A meeting of the **WAVERLEY LOCAL PLANNING PANEL** will be held by video conference at:

AGENDA

50 Gilbert Street, DOVER HEIGHTS NSW 2030 - Modification to increase the height and floor space of the dual occupancies, alter internal layout, pool size and location, windows, enclosure of rear balcony, enlargement of terraces, excavation, and various other alteration. (DA-289/2021)

Report dated 14 February 2023 from the Development and Building Unit.

SECTION B

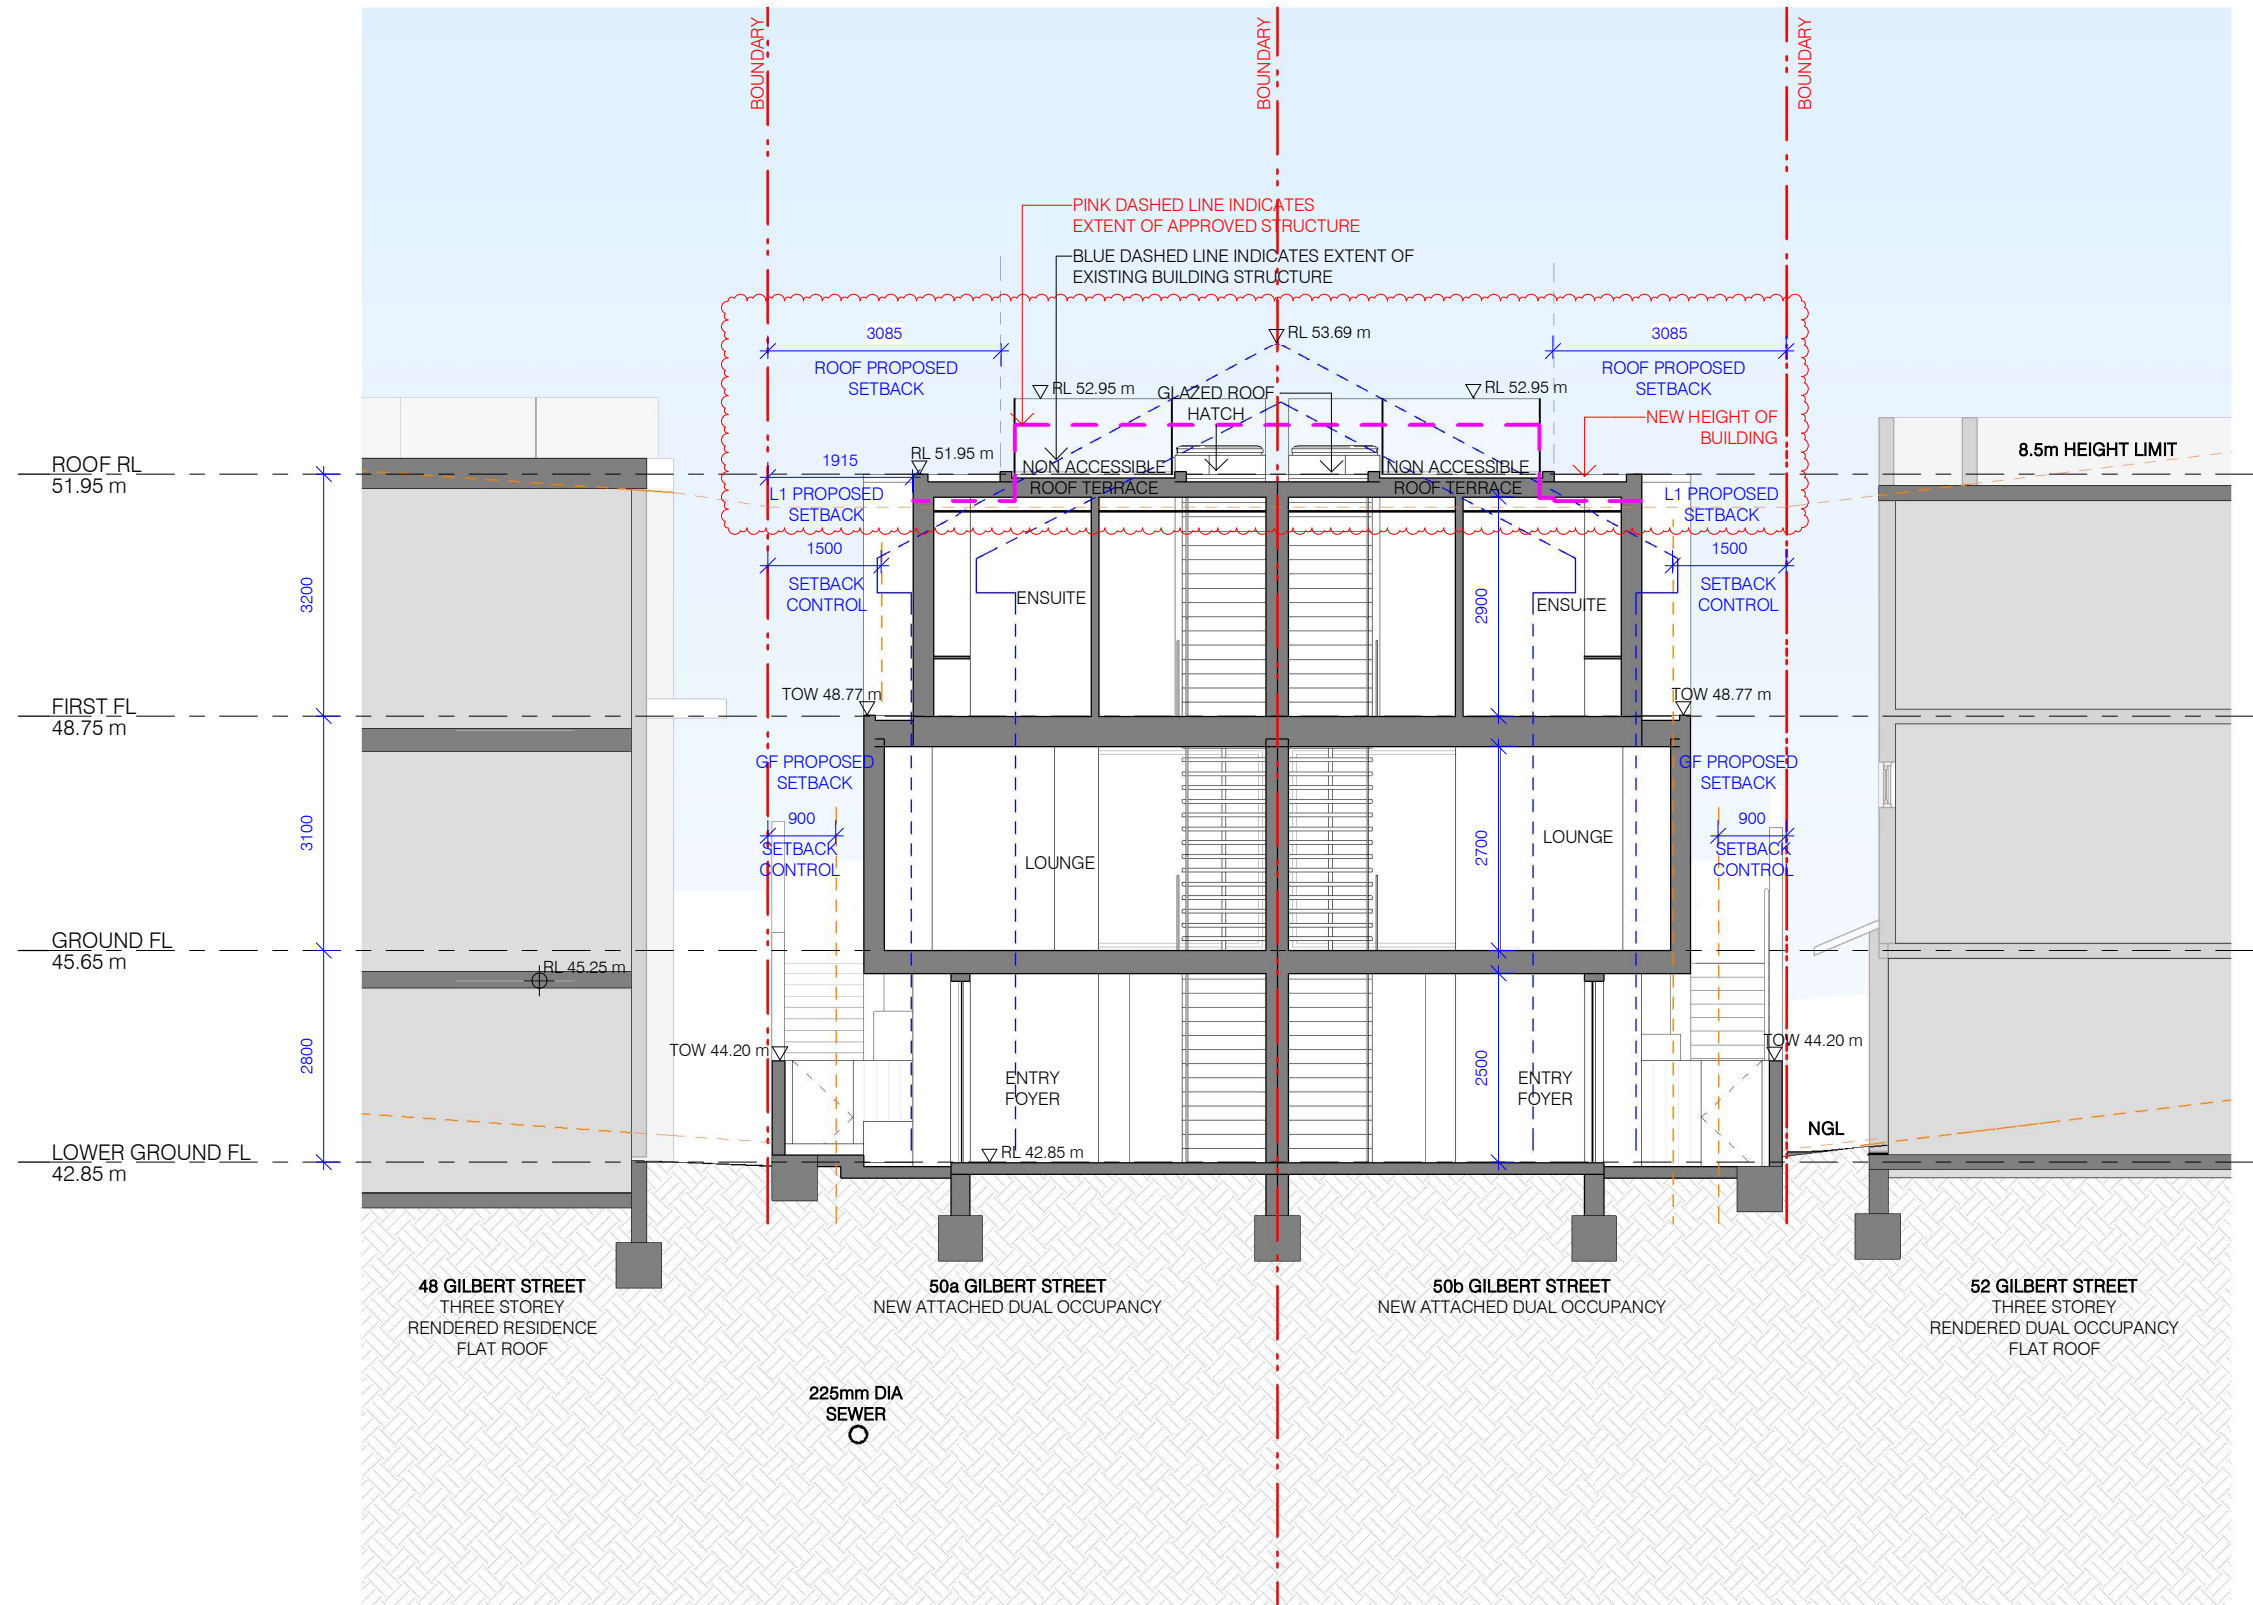
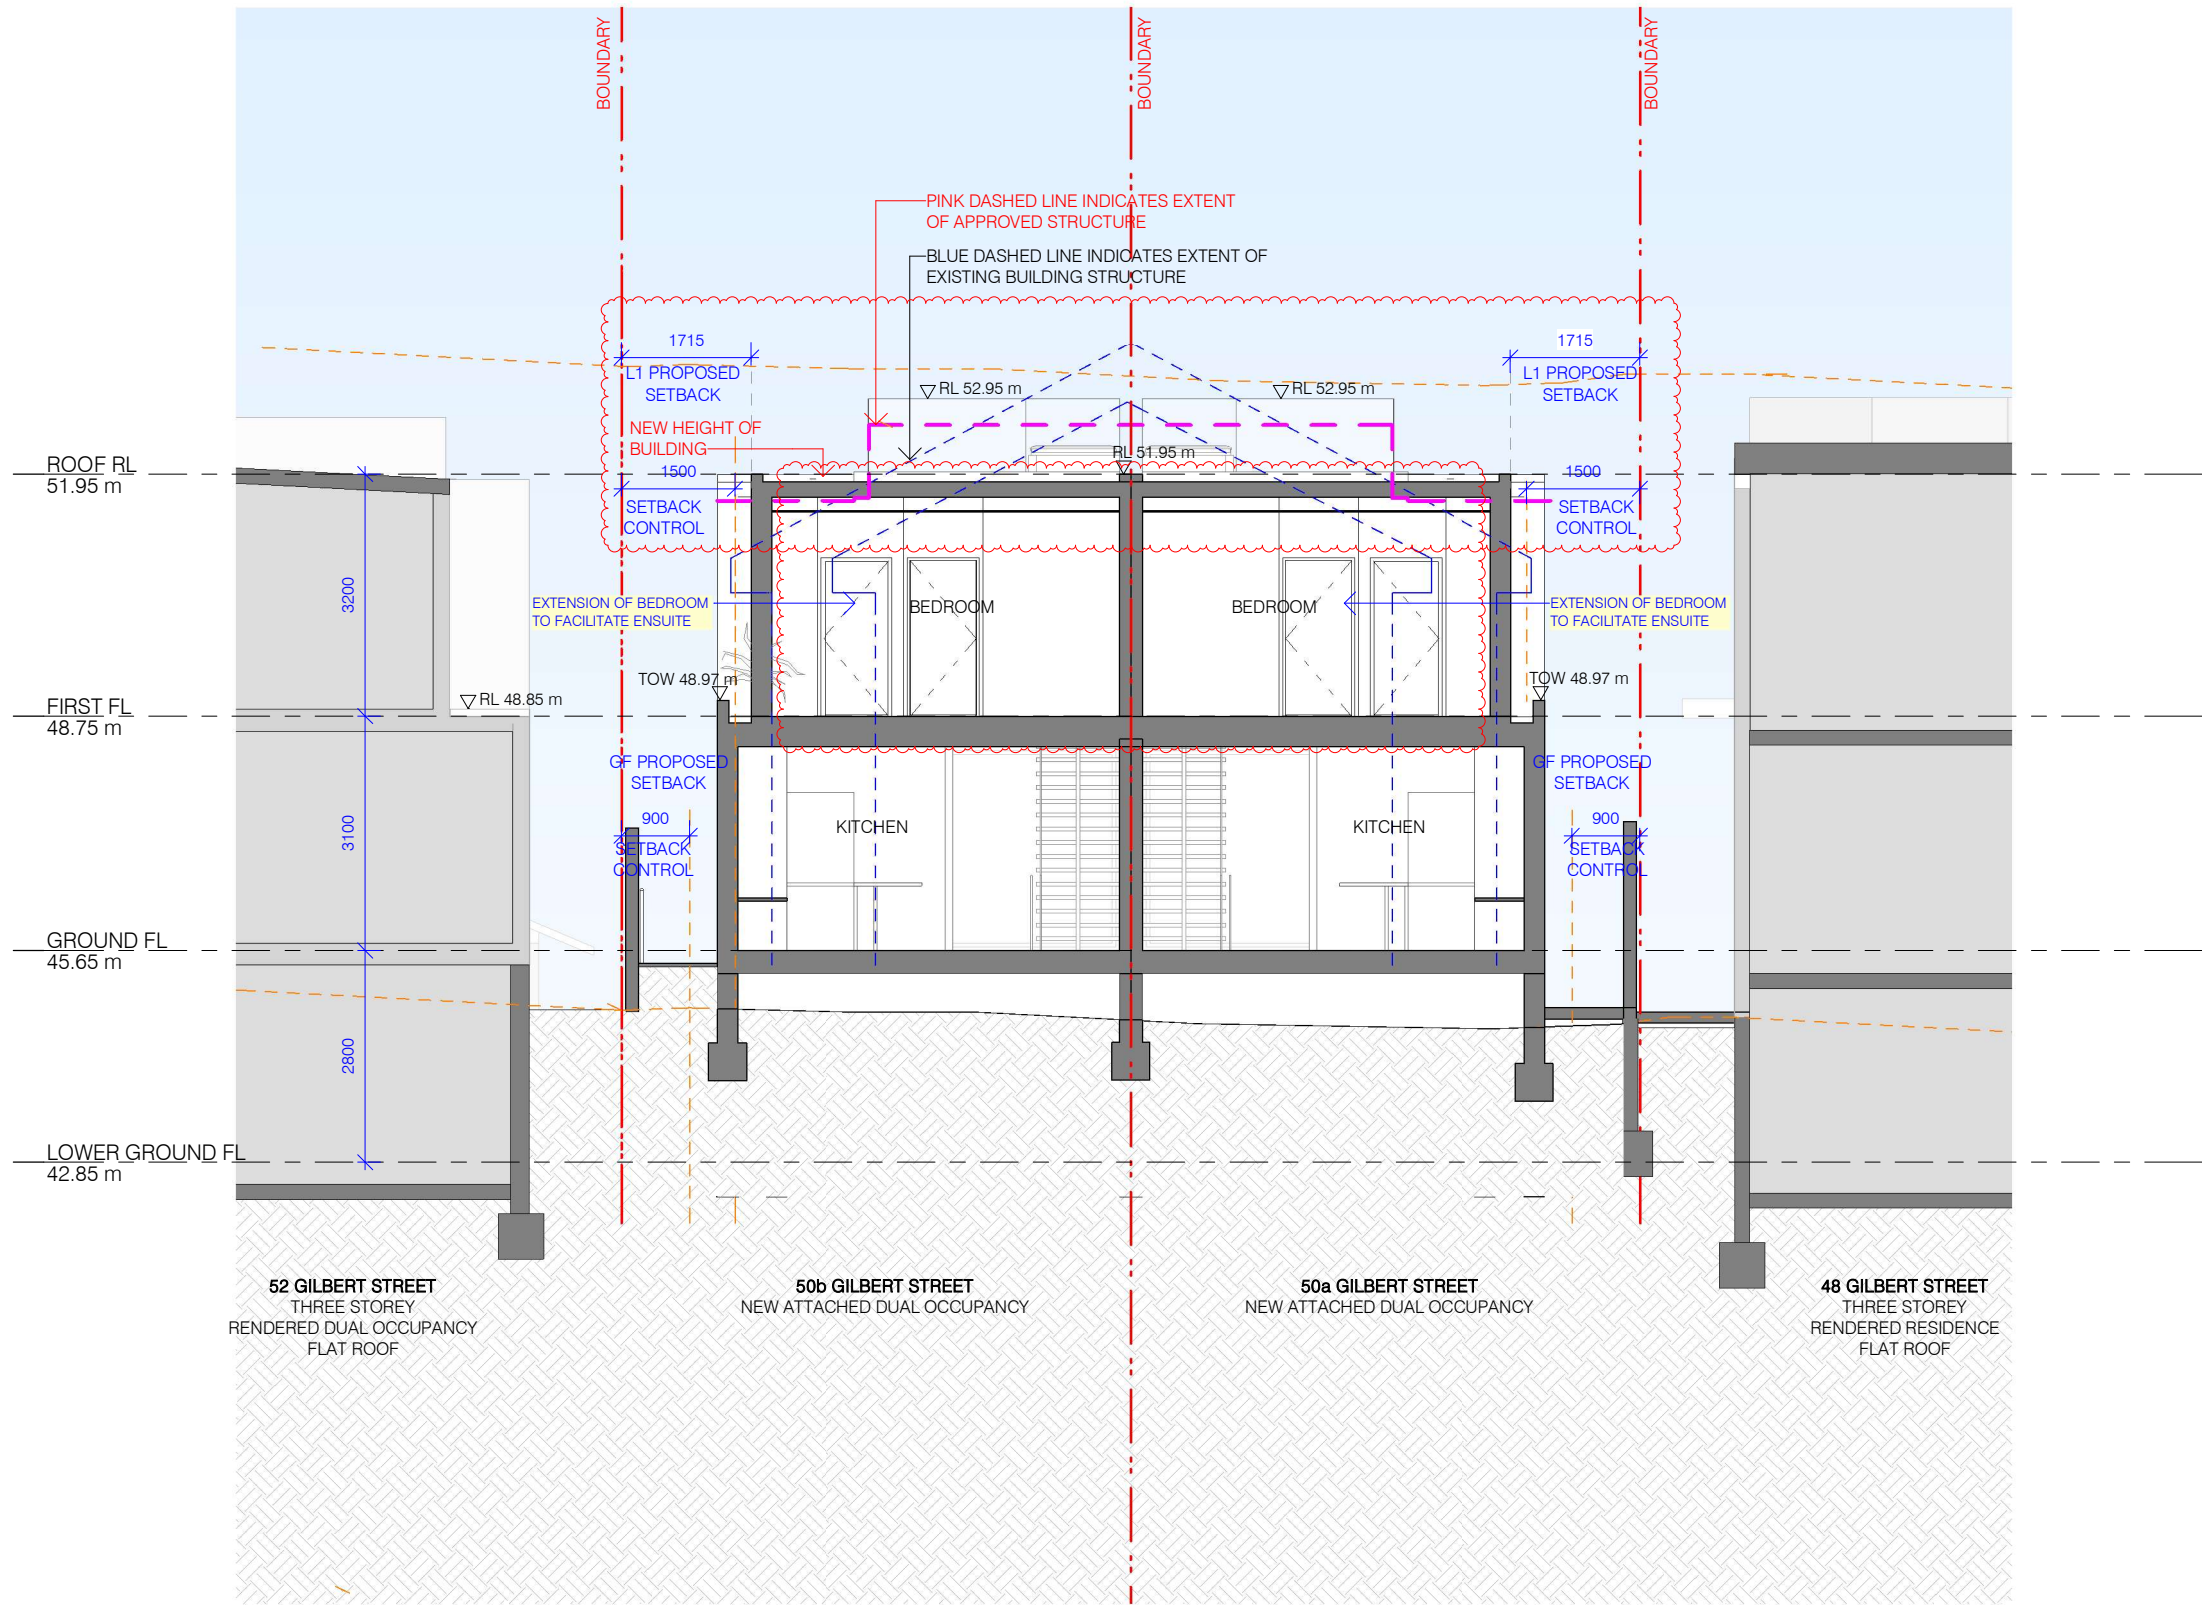
Planner's comment: The Architectural plans are misleading as the floor to ceiling height differs from 2.7m in Section A – Part A and 2.9m in Section B (see **Figure 7**), which would explain the 0.3m increase to the overall building height. The applicant has argued the height increase responds to market expectations which is not a sufficient planning argument in justifying contravening the development standard. The subject site is located in the lowest part of the eastern side of Gilbert Street and is naturally lower than the neighbouring dwellings.
